PRODUCT CHANGE NOTICE

PCN#18-137

MODEL(S) AFFECTED:**ZX Case Series** (See attached list for specific models)**EXTENT OF CHANGE:**

Change of method of Ground Turret Pin assembly

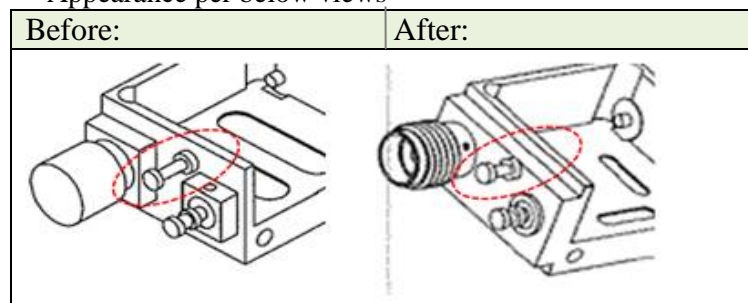
- No change to FUNCTION, Change to FIT and FORM
- Ground Turret Pin changed from insertion and swage assembly to integrated machined design
- Appearance per below views

Improved captivation of the Ground Turret Pin to prevent rotation or wobbling
